Document No.		Addenda No.	1	Date Issued	6/5/2023
Document Title	Magnolia Pier Improvement Project Contract No. 23145				
No. of Pages	15 including attachments

This addendum is being issued to respond to the questions asked via email.

RAVENS MARINE INC.
3295 ORANGE AVENUE KISSIMMEE, FL
PHONE: 407-935-9799 FAX: 407-935-9436
MAGNOLIA PIER, SHORE RD, GLOUCESTER, MA 01930
RAVENS CUSTOMER: BTT MARINE
3'-6" x 40'-0" MARINER-I GANGWAY
DATE: 3/23/20 SHEET: 1 OF 2 DWG NO.: RM-1

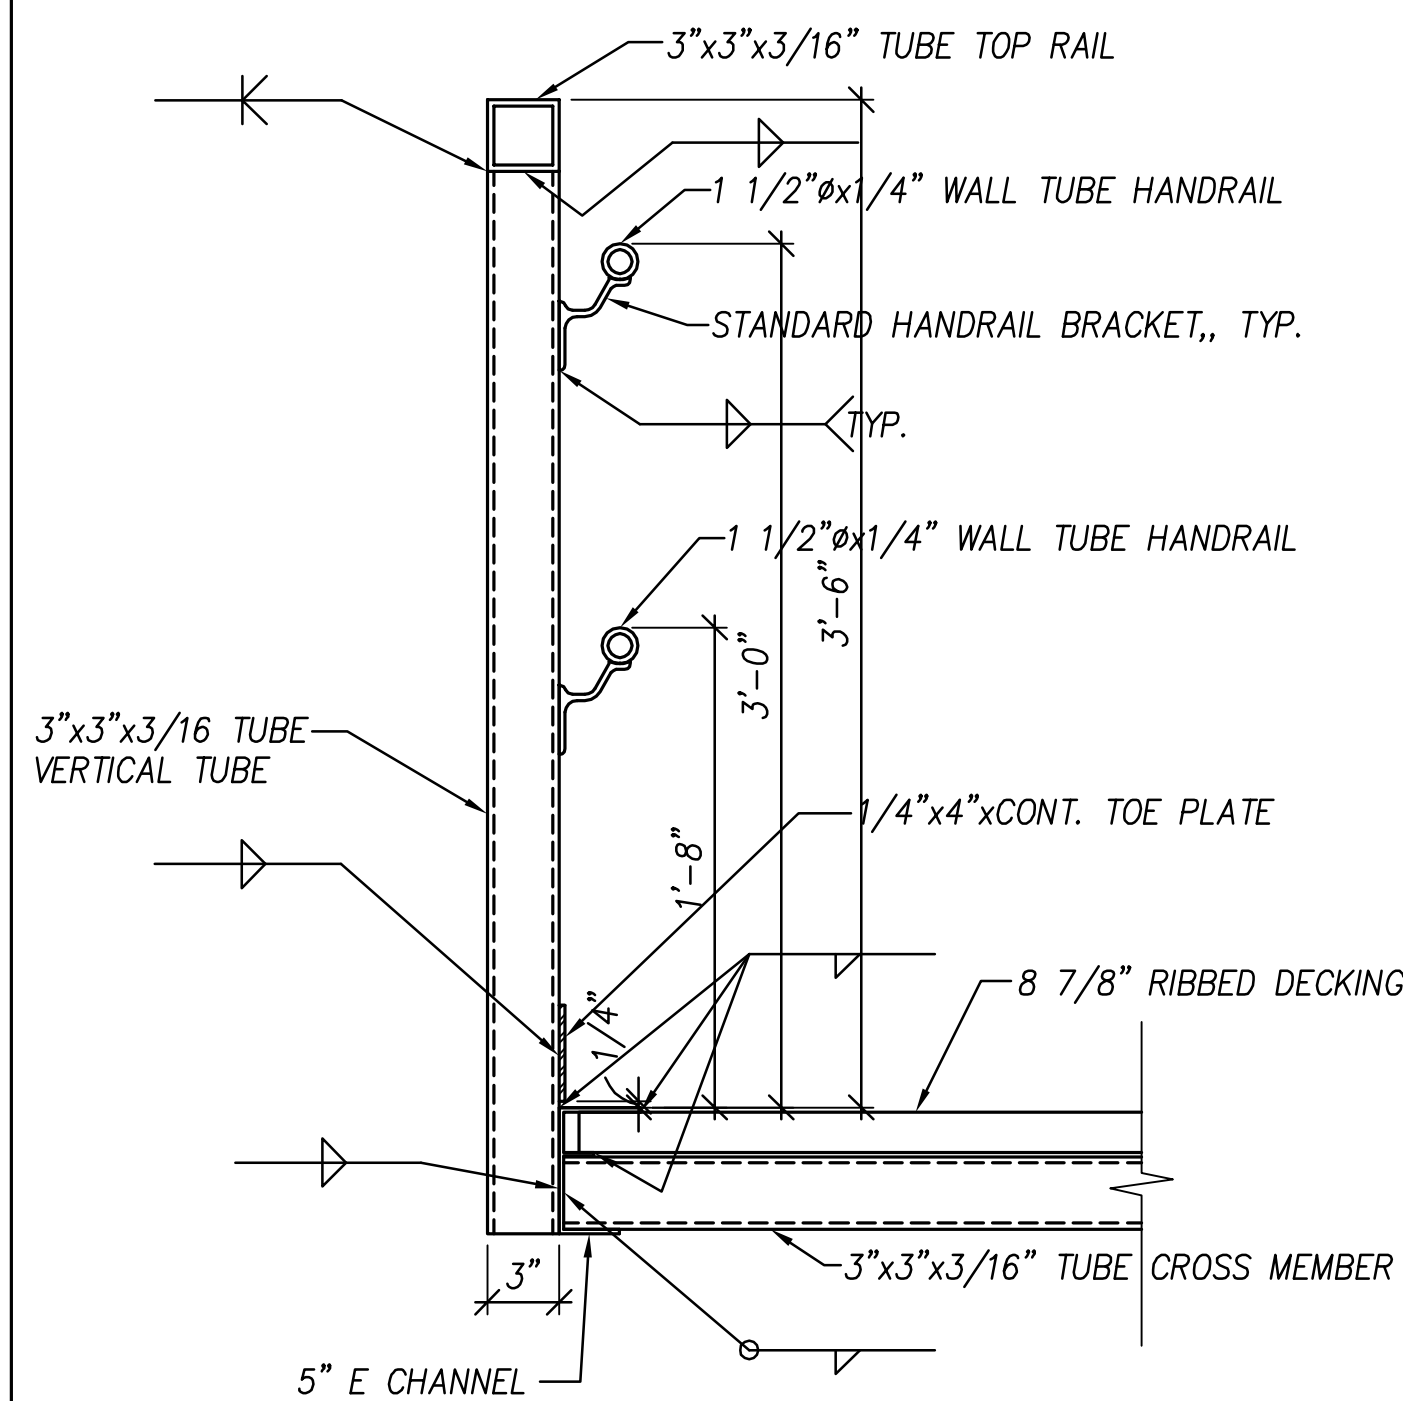
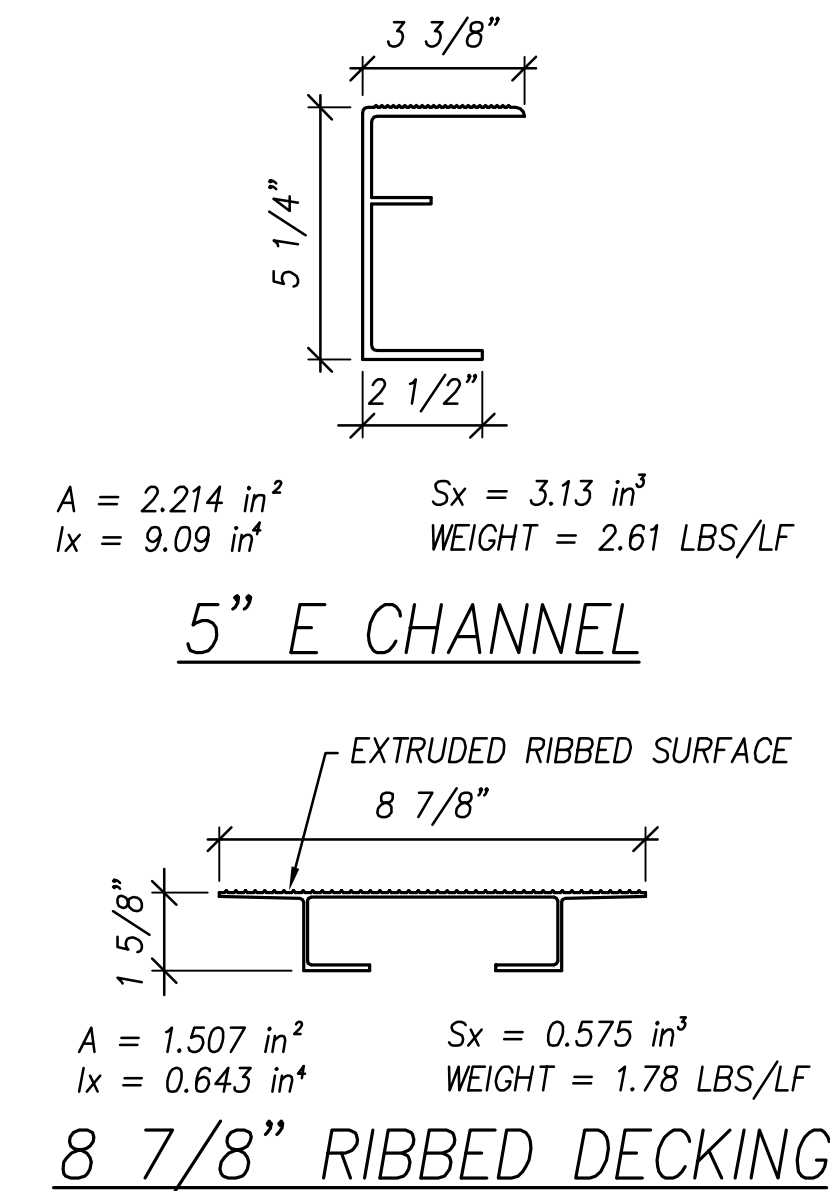
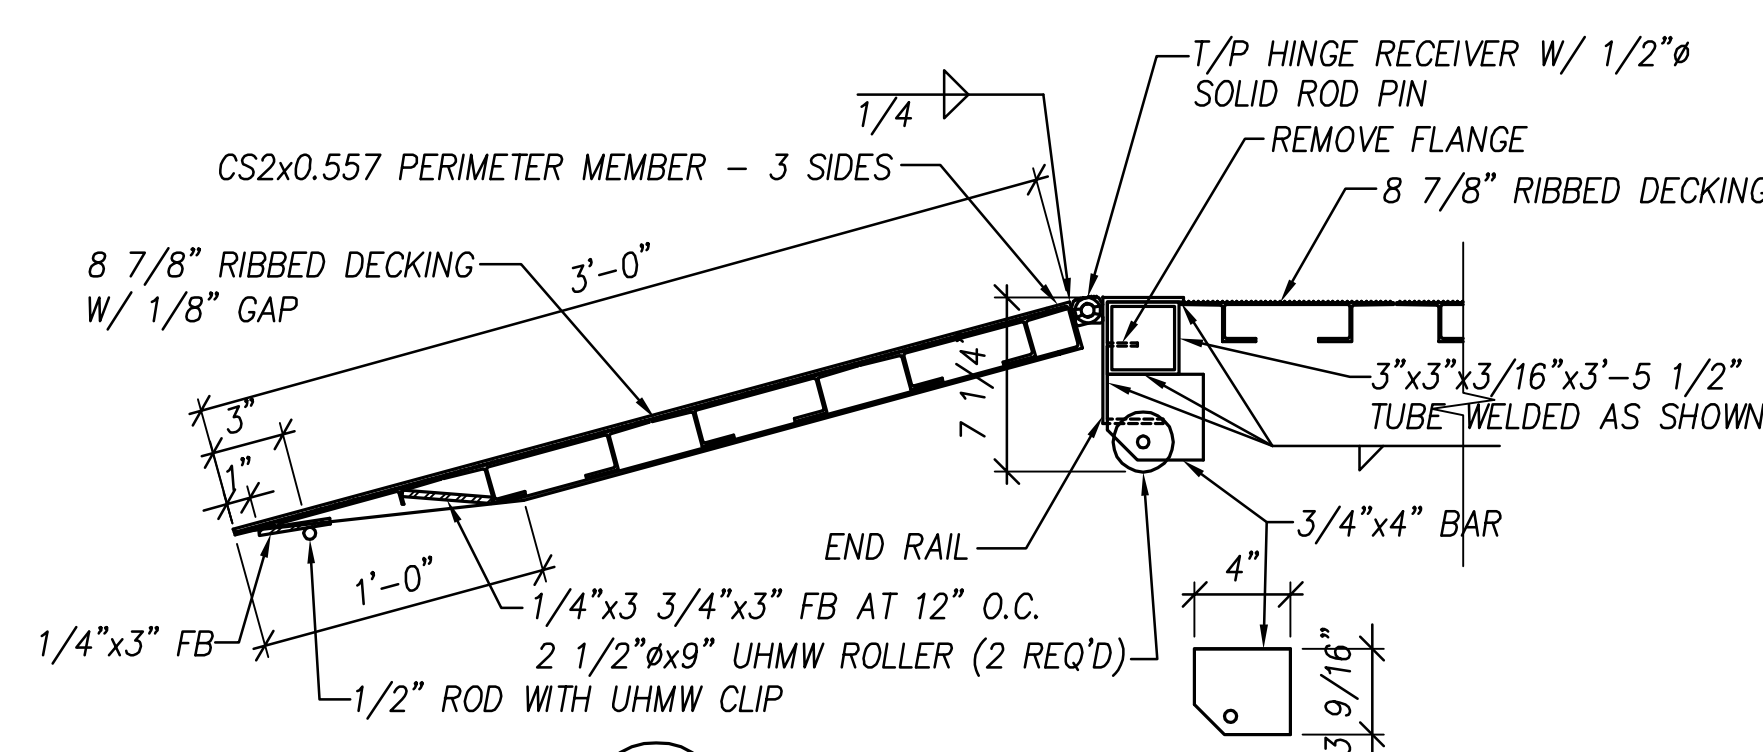
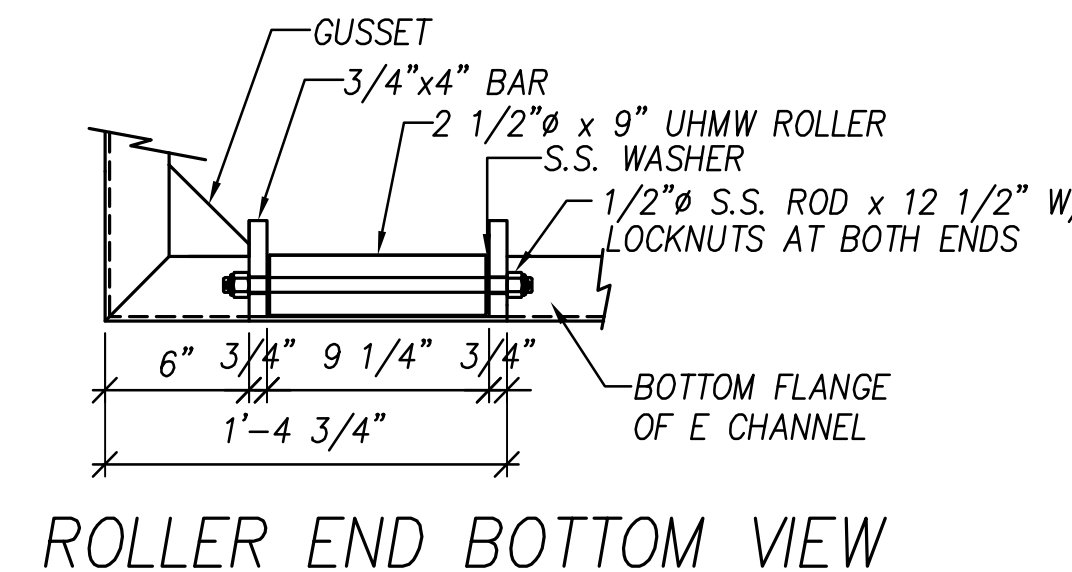
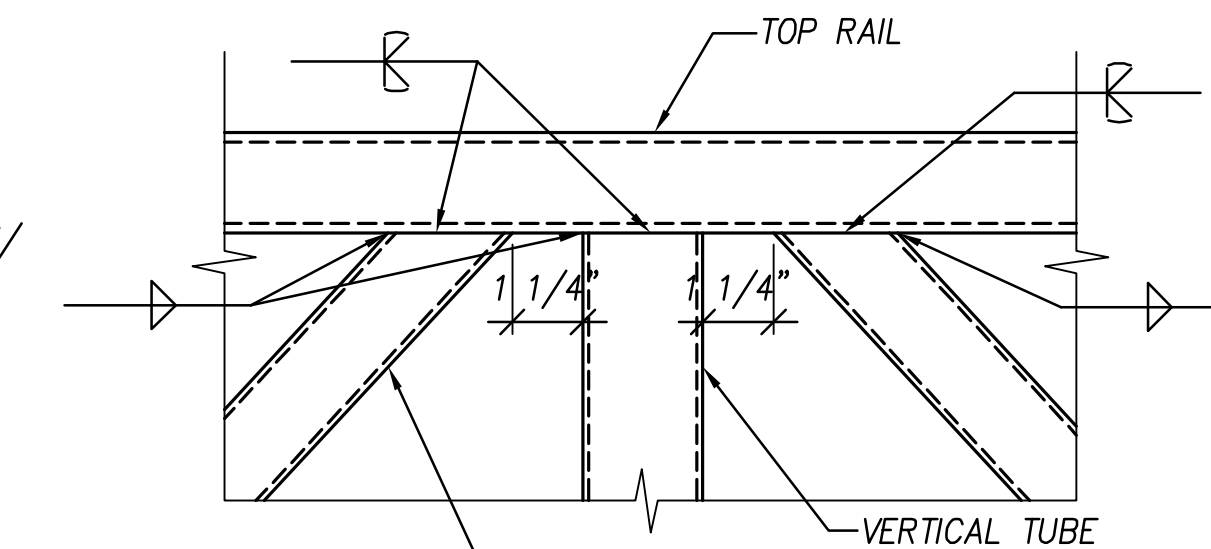
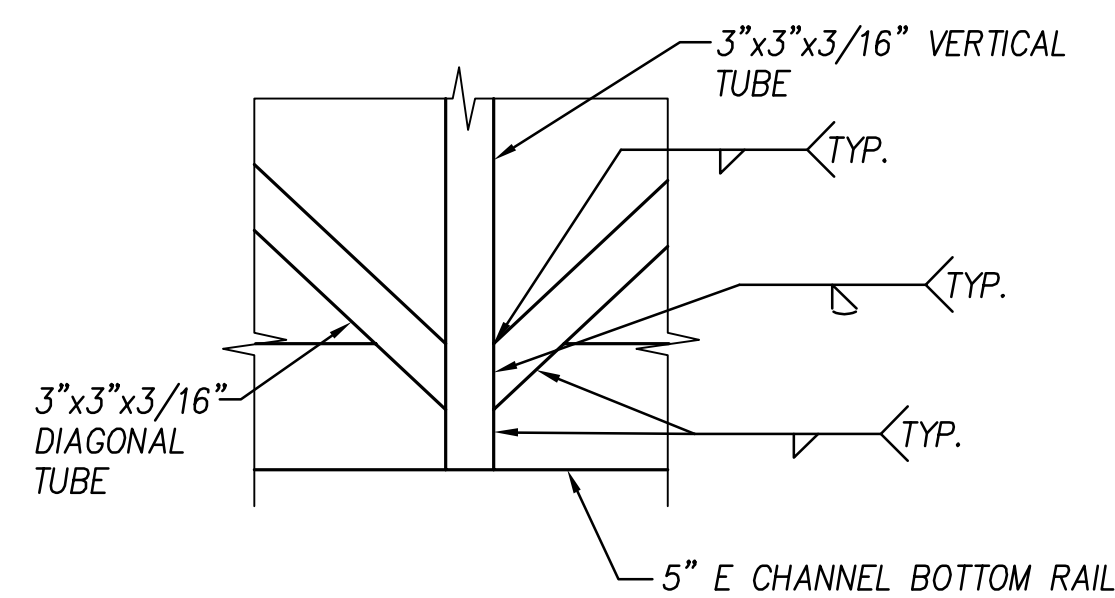
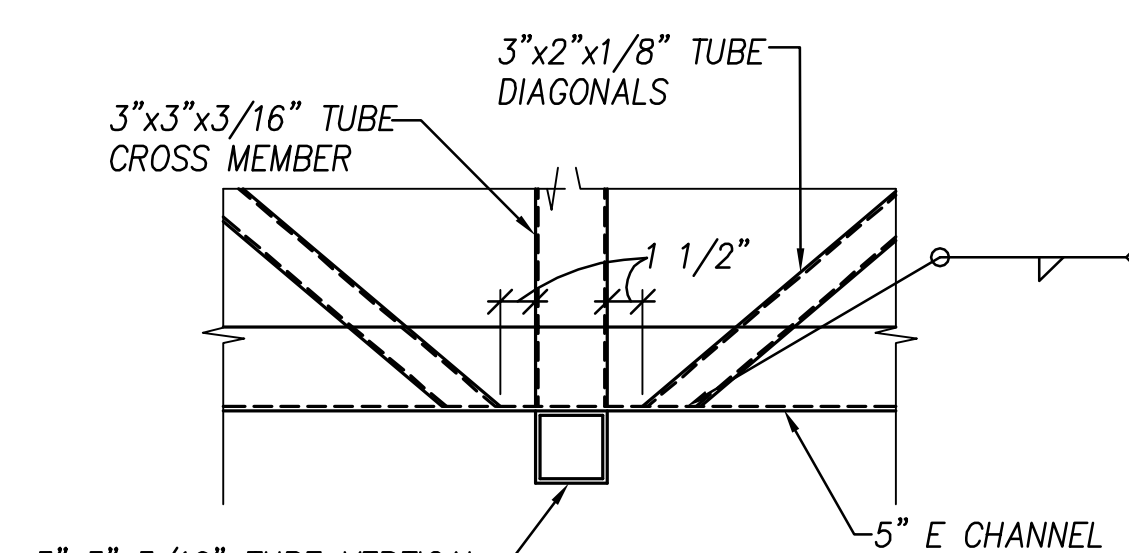
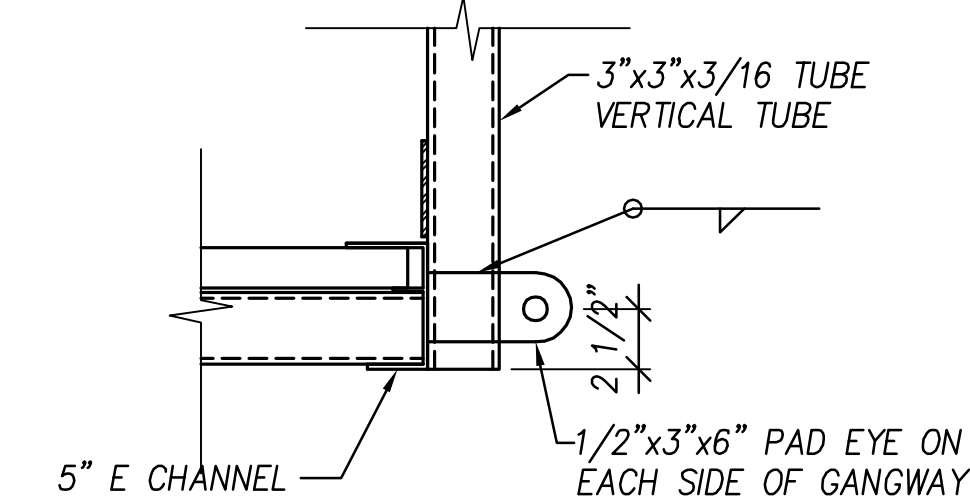
Response	That is correct. Raising of the pier structure is not included in this project.
Question #23	Please provide an as-built shop drawing for the existing gangway 5th wheel hinge connection.

Response	Refer to Attachment B.
Question #24	Please specify the components of the 5th wheel hinge scheduled to be replaced.
Response	The City will procure the 5th wheel hinge components. The Contractor's responsibility will be to install provided materials and evaluate existing pier gangway connections.
